AEP:NRC:0055F

D. C. COOK - UNIT 1

LIST OF CHANGES  
TO  
APPENDIX A TECHNICAL SPECIFICATION

D. C. COOK - UNIT 1  
DPR-58

FIGURE 5.1-3  
SITE BOUNDARY FOR GASEOUS AND LIQUID EFFLUENTS

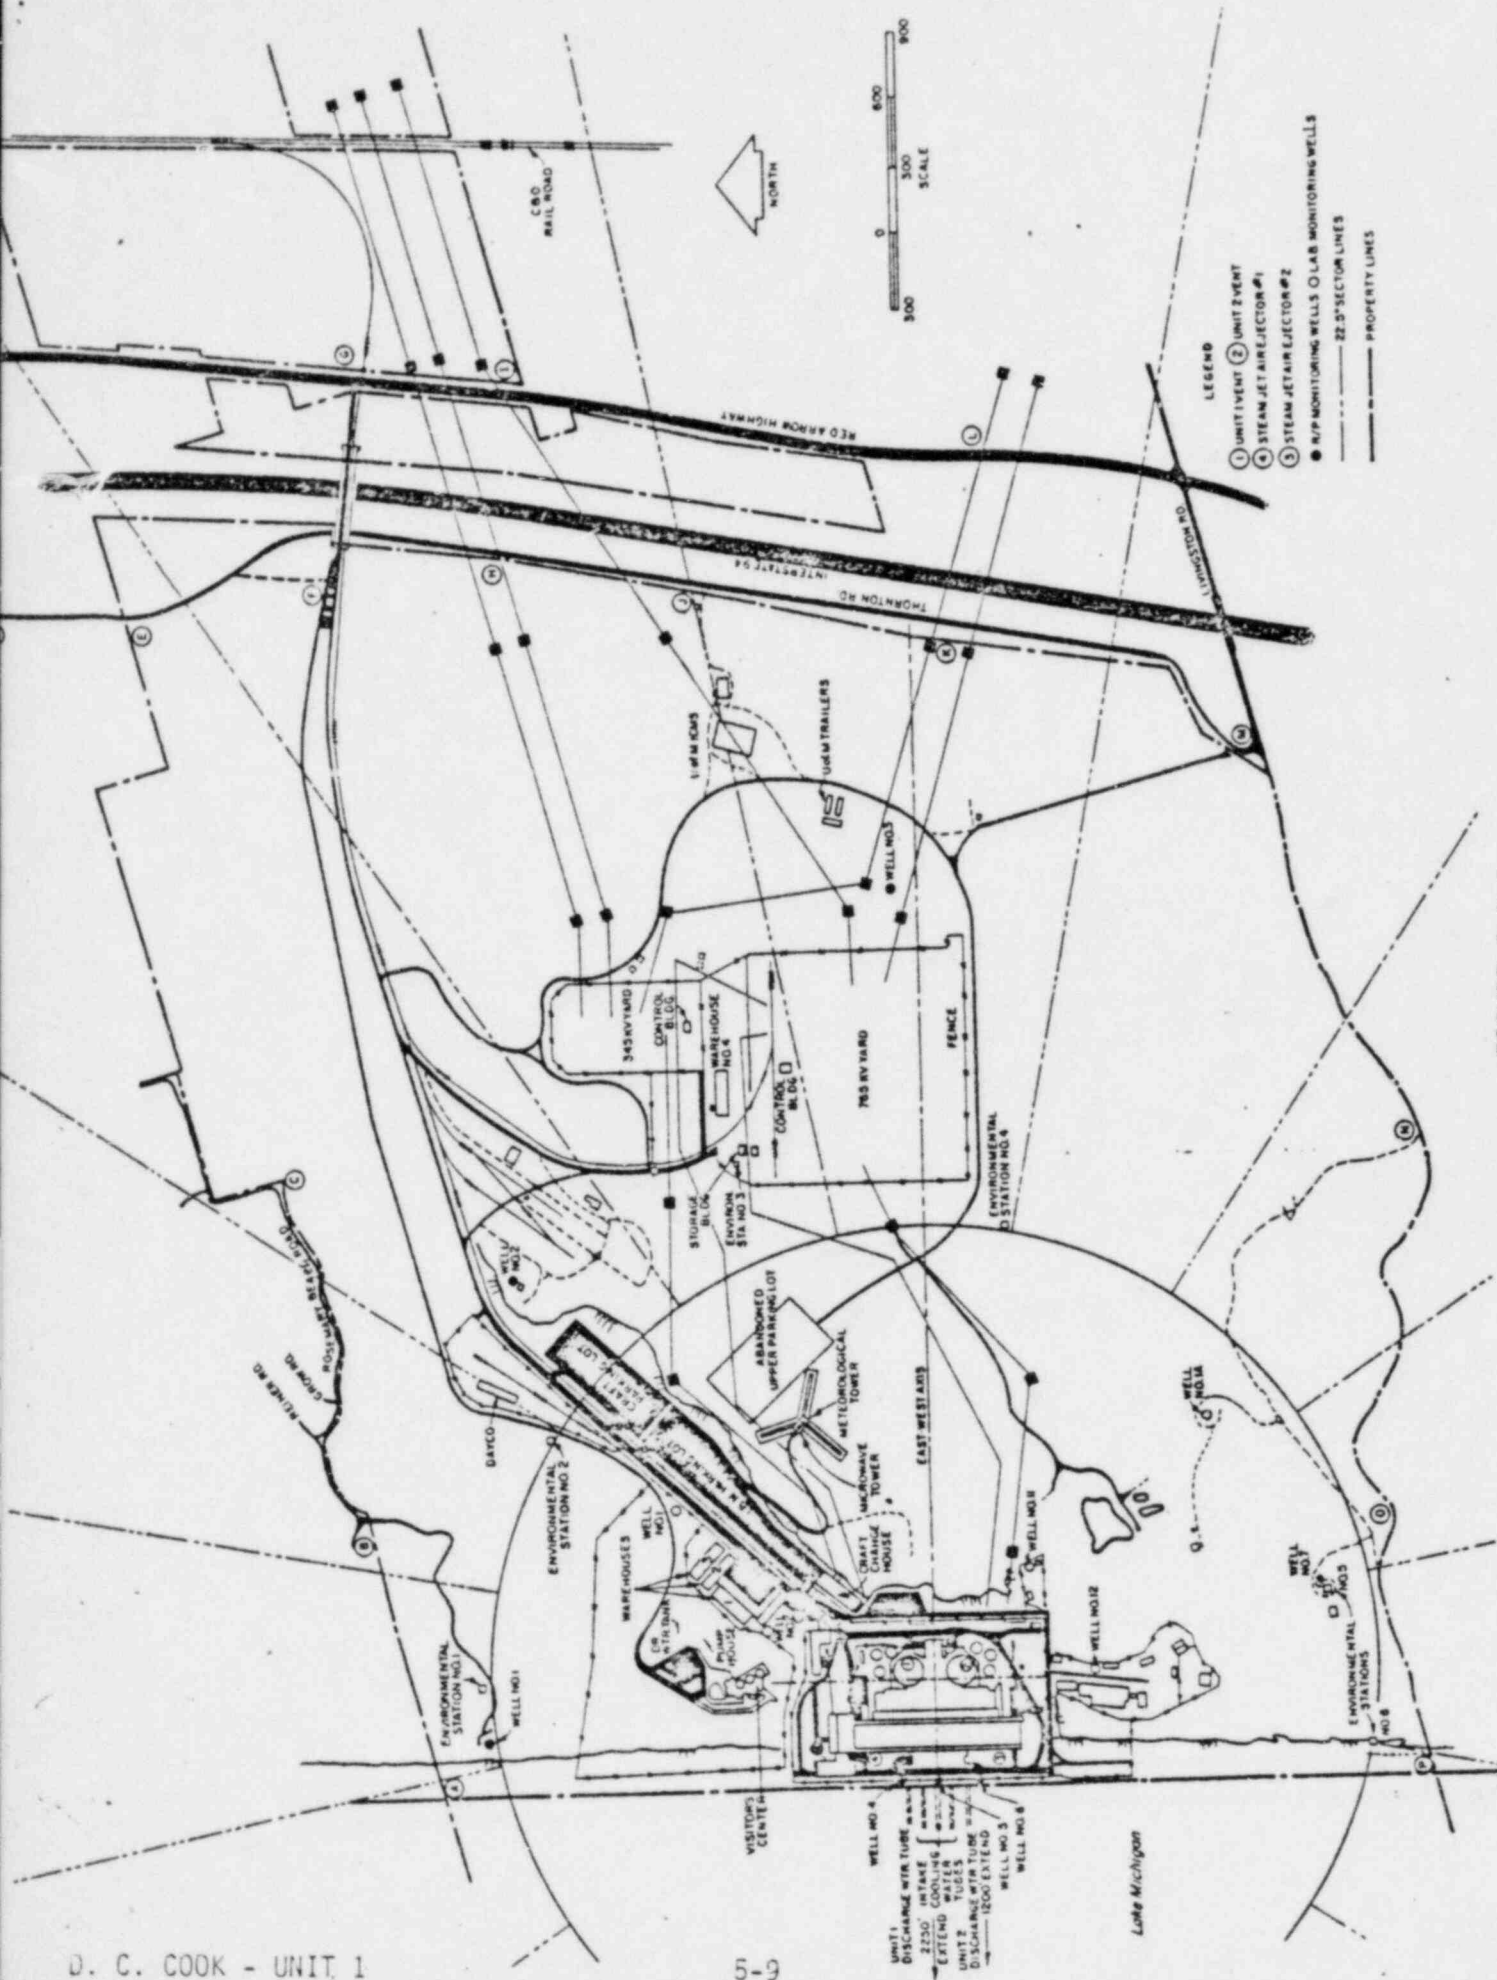
5.1.3 The site boundary for gaseous and liquid effluents shall be shown in Figure 5.1-3.

FIGURE 5.1-5  
SITE BOUNDARY FOR GASEOUS AND LIQUID EFFLUENTS

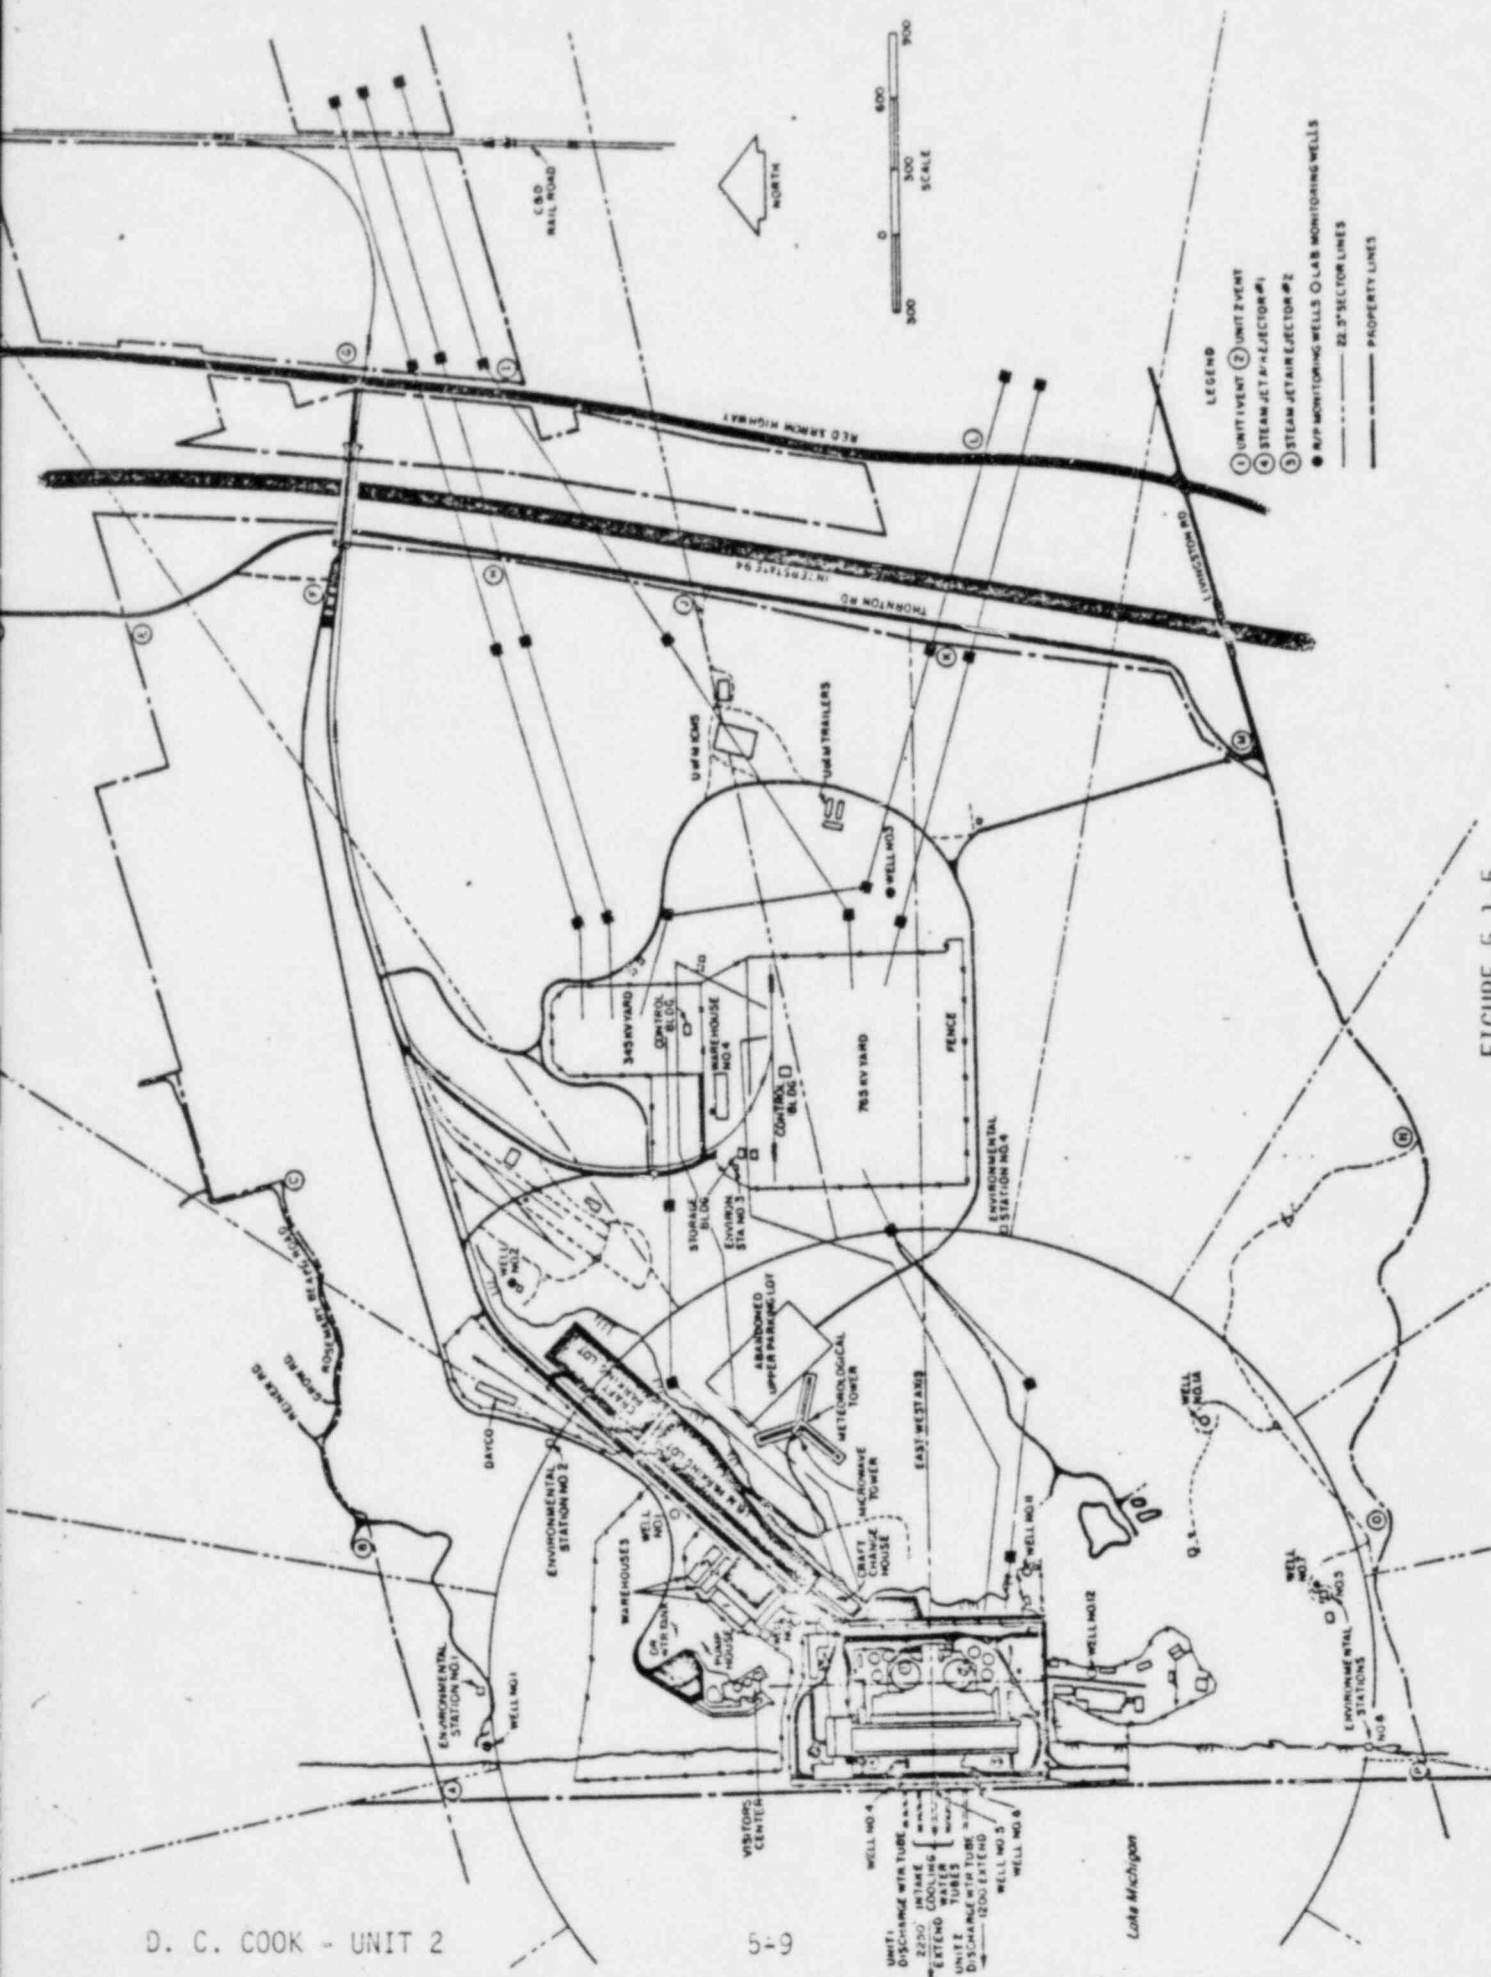
5.1.3 The site boundary for gaseous and liquid effluents shall be shown in Figure 5.1-3.
